# Access Compliance Report

## Public Rights-of-Way

### (Curb Ramps)

Intersection ID: 19817	Main Street: MONROE_RD	Cross Street: TIMBER_SPRINGS_DR	Location: NE
ADA ID: 5742F0731501	Ramp Type: Perp	Initial Pass/Fail: Fail	Overall Compliance: No
Severity Score: 12.5			
Codes/Mitigation Info/Possible Solution		Field Measurements/Component Compliance

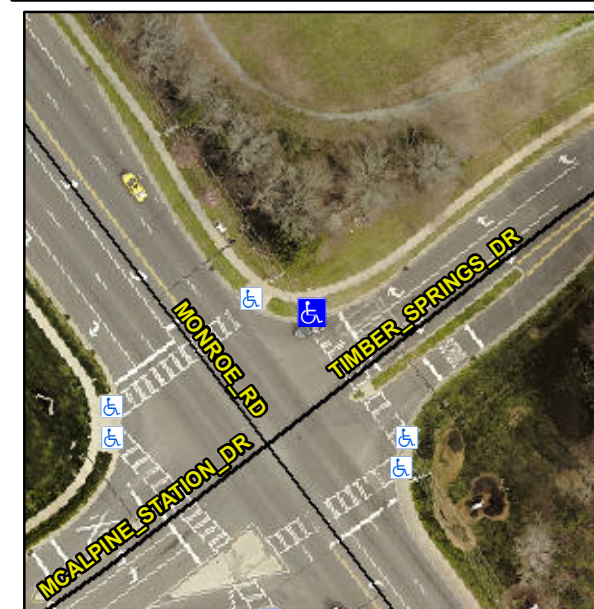
Compliance	Description	Data	Compliance	Description	Data
N/A	Ramp Length (in)	96.0	No	Ramp Slope (%)	9.2
Yes	Ramp Width (in)	48.0	Yes	Ramp XSlope (%)	0.9
N/A	Flare Type LT	N/A	N/A	Flare Type RT	N/A
N/A	Flare Slope LT (%)	N/A	N/A	Flare Slope RT (%)	N/A
N/A	Flare Traversable LT?	N/A	N/A	Flare Traversable RT?	N/A
N/A	Landing Length (in)	N/A	N/A	DWS Provided?	N/A
N/A	Landing Width (in)	N/A	N/A	DWS Contrast?	N/A
N/A	Landing Slope (%)	N/A	N/A	DWS Length (in)	N/A
N/A	Landing X Slope (%)	N/A	N/A	DWS Full Width?	N/A
N/A	Landing Curb? (Y/N)	N/A	N/A	DWS Offset (in)	N/A
N/A	Shared Landing?	N/A			
N/A	Gutter Ponding?	N/A	N/A	Gutter Slope (%)	N/A
N/A	Gutter Lip Ht (in)	N/A	N/A	Gutter X Slope (%)	N/A
N/A	Painted X Walk1?	Yes	N/A	Painted X Walk2?	N/A
	X Walk 1 Direction	To SE		X Walk 2 Direction	N/A
N/A	X Walk 1 Width (in)	112.0	N/A	X Walk 2 Width (in)	N/A
	X Walk 1 Slope (%)	1.0		X Walk 2 Slope (%)	N/A
	X Walk 1 X Slope (%)	2.3		X Walk 2 X Slope (%)	N/A

**Remove & Replace Entire Ramp.**
